**BOARD OF SUPERVISORS
PUBLIC HEARING
STAFF REPORT**

SUBJECT: ZCPA-2020-0003, True North Data

PURPOSE: To consider a Zoning Concept Plan Amendment (ZCPA) of True North Data (ZMAP-2017-0003) in order to allow for the option to consolidate three previously approved buildings shown on the Concept Development Plan (CDP) into one building. Should the site develop with one building, the maximum height has been proposed by the applicant to increase from the proffered maximum of 35 feet to 56 feet.

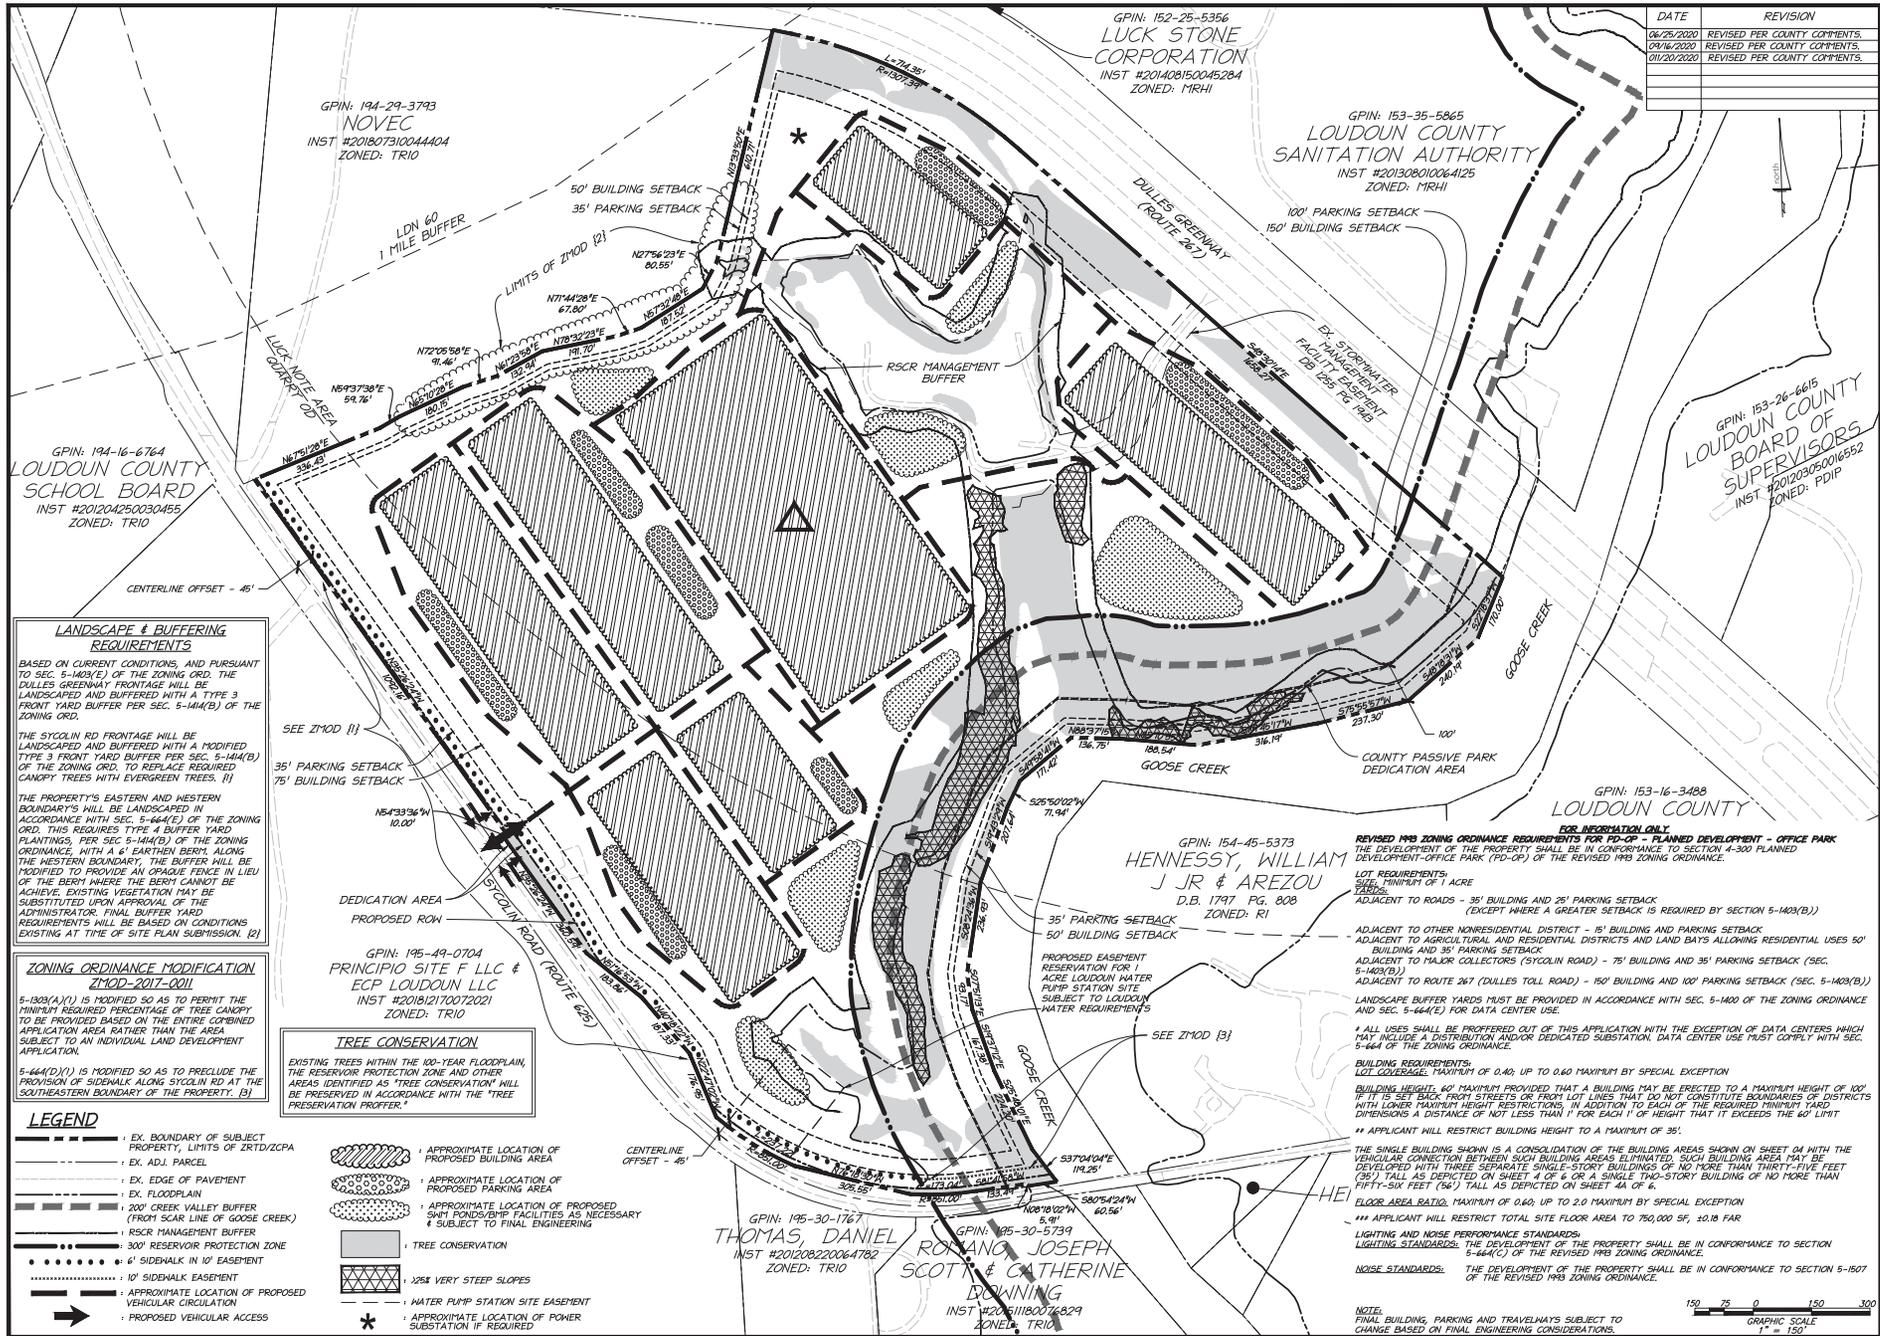
Comment 2. Revise Sheet 4 to show the approved Administrative Change to the circulation elements of the approved CDP as depicted on Exhibit D of ZCOR-2018-0252.

Comment 5. Concept Development Plan. Sheet 4. Revise the references to Section 5-900 in reference to the building and parking setbacks adjacent to Major Collectors (Sycolin Road) and adjacent to Route 267 to reference Section 5-1403(B).

Response: Sheet 4 of the CDP has been updated to depict changes to the internal circulation of the development as approved with the Administrative Change (ZCOR-2018-0252) .

Response: Sheet 4 of the CDP has been updated to reference the updated Zoning Ordinance section.

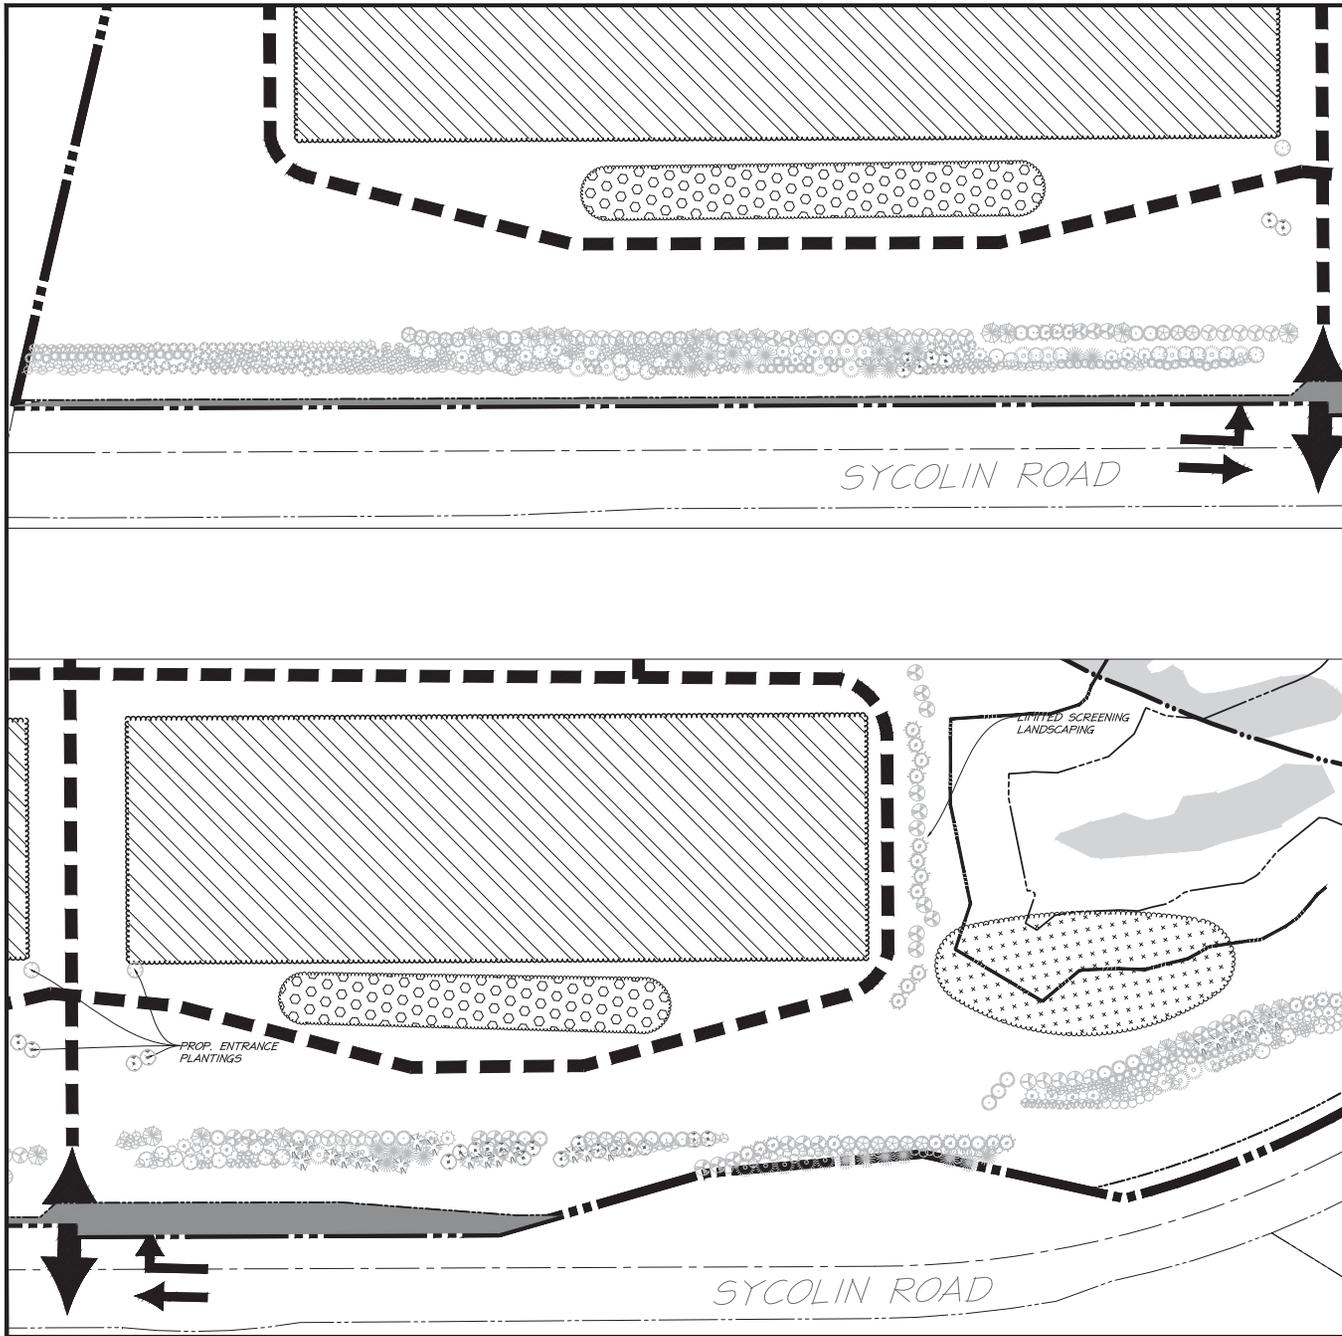
- a) Staff also notes that per Sheet 4A, the footprint of the single building on this sheet is bigger than the building footprint of the 3 buildings on Sheet 4. Staff also notes that when the RSCR Management Buffer is expanded to include the protection of the Very Steep Slopes as it was previously depicted, it will result in more impacts to the Management Buffer. Staff has concerns regarding these impacts and recommends using a building footprint similar to that on Sheet 4 in order to provide the best protection to the natural resource features on this site.

- 2) Sheet 4A- Show reforestation areas proposed for encroachments into the RSCR so staff know they are appropriate.

Comment 2. County Urban Forester. Sheet 4A – Show reforestation areas proposed for encroachments into the RSCR so staff know they are appropriate.

Comment 1. Amend the building height note on Sheet 4a as it currently references three buildings with a triangle symbol that are not shown on Sheet 4a. Amend the note to match what is depicted on the sheet.

Response: Sheet 4A has been added to the CDP which depicts the "Proposed Building Consolidation" development option as noted in the Statement of Justification.

Response: As requested, the building height note has been revised on Sheet 4A.
